VERMONT YANKEE NUCLEAR POWER CORPORATION

Subject: Additional Information Submitted in Support of Request for
Exemptions - 10CFR Part 50, Appendix R

ADDITIONAL INFORMATION - Submitted in Support of the March 14, 1984 Request for Exemptions from 10CFR50 Appendix R: Items 4 and 6.

Figure 1

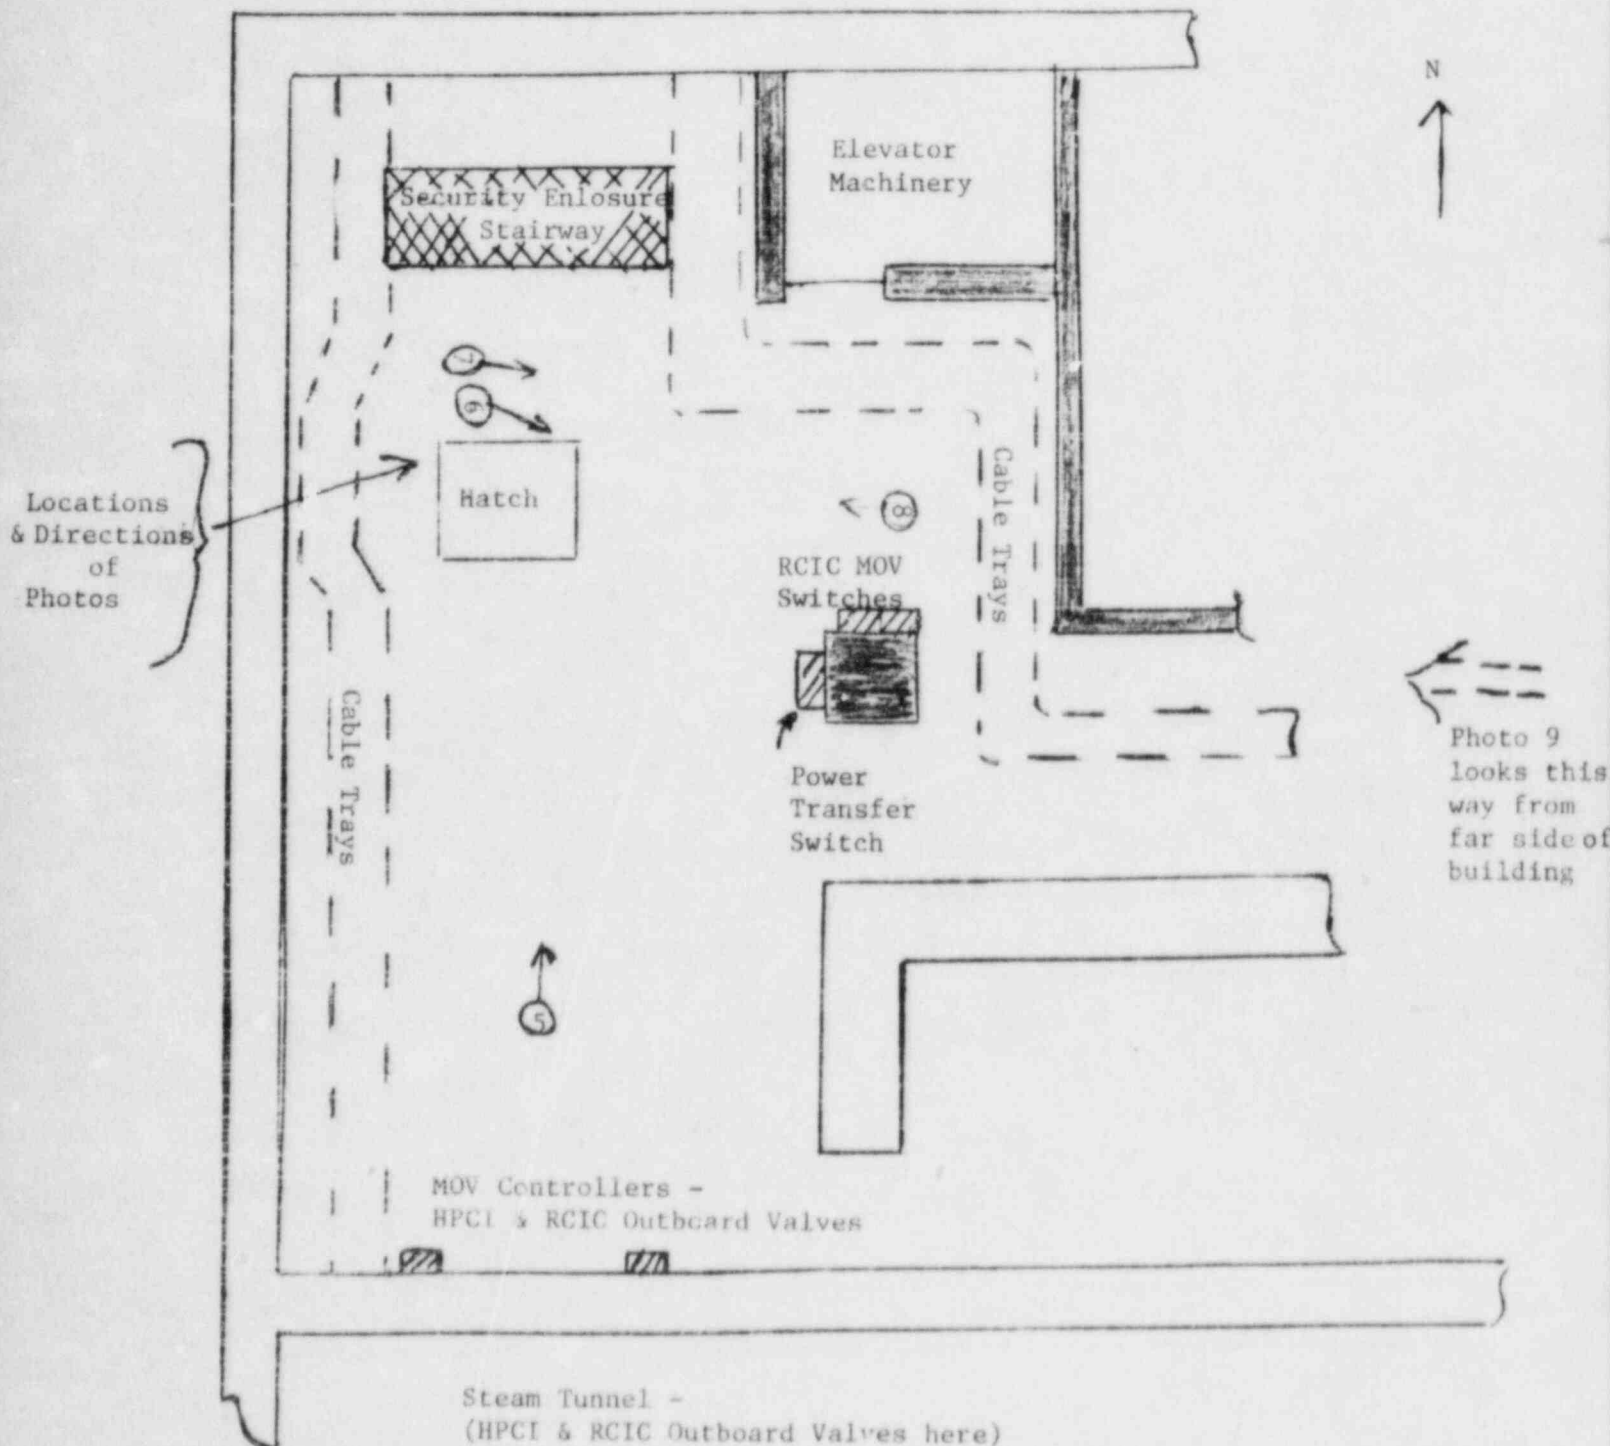
As shown in the enclosed sketch (Figure 1), the trays are currently separated by approximately 20 feet, then diverge further. This area between the trays is shown in Photo 5, previously submitted with Reference (b). Additionally, intervening combustibles are slight, as evidenced by Photos 7 and 8 of Reference (b), which show the banks of trays for each train.

On the column at the center of the enclosed sketch are a power transfer switch and control switches for the RCIC steam line inboard and outboard valves. The cable and switches are enclosed in conduit and control boxes minimizing the concern for this area as a source of intervening combustibles. The controller for the inboard valve is out of this area, located on MCC 89B in the northeast corner of the building. The outboard valve is accessible for manual operation in the steam tunnel, which is entered by a door on the south side, out of the fire area. Therefore, any potential hot shorts affecting these controls could be overcome by manual action outside the fire area.

HPCI and RCIC outboard steam line valve controllers are located on the south end of this area, on the north wall of the steam tunnel, as shown in the sketch, (no photo taken). The HPCI outboard valve is also available for manual operation in the steam tunnel. Thus, in the unlikely event of hot shorts closing any of these normally open steam line valves, they could be opened by the operator outside the fire area.

The floor at level 252 is mostly thick reinforced concrete. There is a bolted steel plate hatch for machinery access, and a stairway as shown in the sketch (Figure 1). The stairway is enclosed by a heavy steel plate security enclosure. Power cables in the room below, at floor elevation 232'. This is discussed in Exemption Request No. 1 of Reference (b). Since there will be suppression in the rooms above and below this floor, and the power cables are not in contact with the underside of the floor and not directly under the hatch, but about six feet below [see Photos 22 and 23 of Reference (b)], the probability of a fire on either side of this floor affecting equipment on the other side is extremely small.

Figure 2

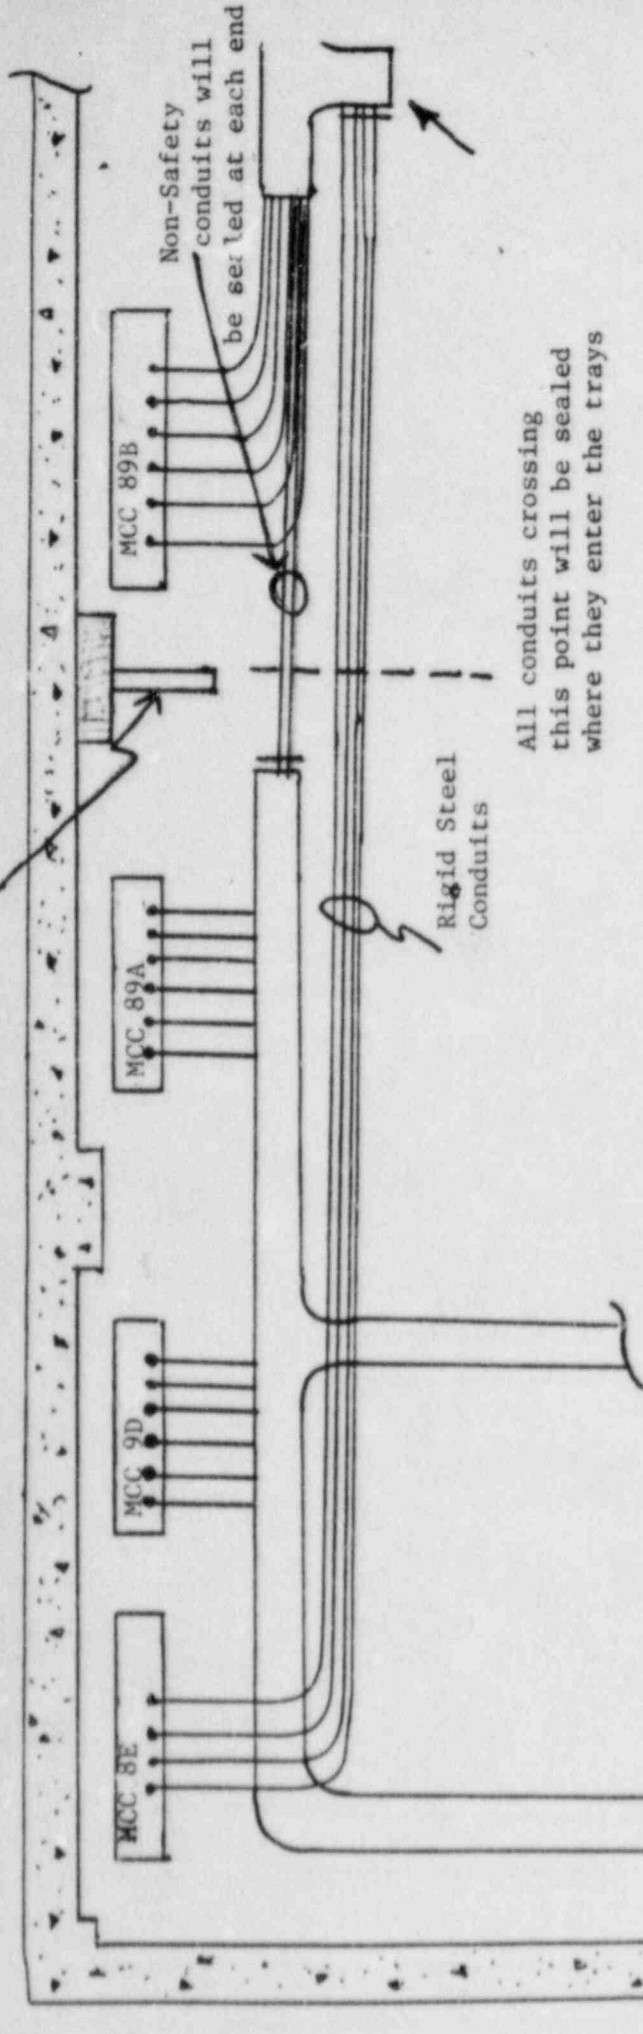
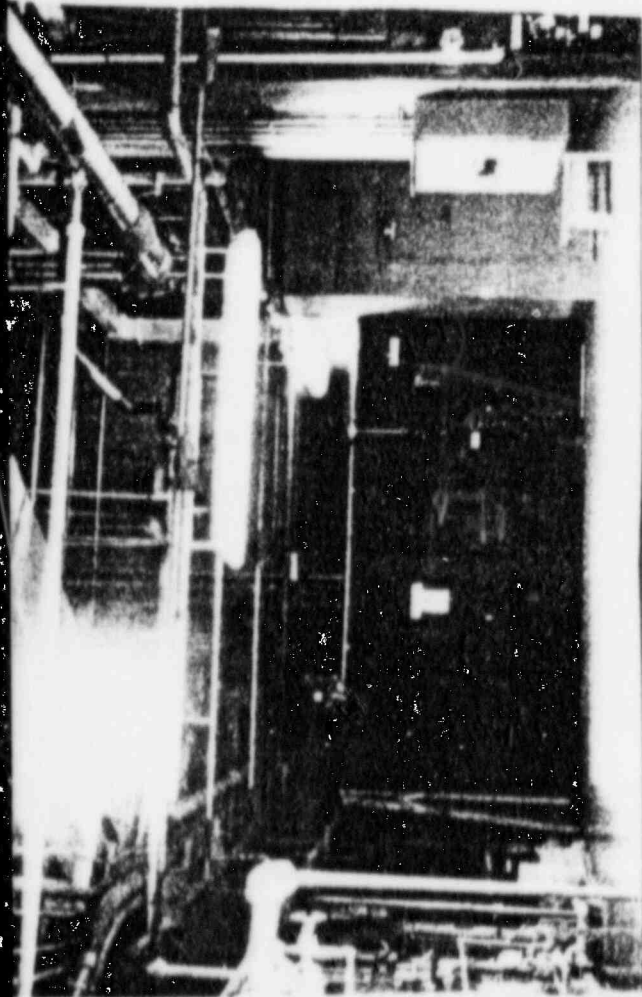
Additional information enclosed in support of this exemption request includes: a sketch (Figure 2) of the Reactor Building Elevation 252' Northeast Corner ground floor, which identifies the location of the modifications to be installed; and three photographs which illustrate the MCCs and cable trays in the northeast corner vicinity (These photos are views looking east and show the MCCs in question. These photos are identified on the enclosed sketch as Photo 10.a, 10.b, and 10.c, and provide an eastward view corresponding to the previously submitted Reference (b), Photo 10).

We will install approved fire stops in all conduits that span the subject MCCs. These stops will be installed in those conduits which accept cables from the two cable trays that run part of the way between the MCCs. In addition, any other conduit that shares a common enclosure away from this area will also be fire stopped. With the installation of the above fire stops, a fire cannot propagate from the area of one MCC to the other MCC via cable nor can a fire concurrently propagate from another outside area to both of the MCCs.

We will also install a radiant heat shield between MCC 89A and 89B. This shield will extend up approximately 14 feet and at least four feet out from the wall as shown in Figure 2.

Radiant Heat Shield

All conduits crossing
this point will be sealed
where they enter the trays
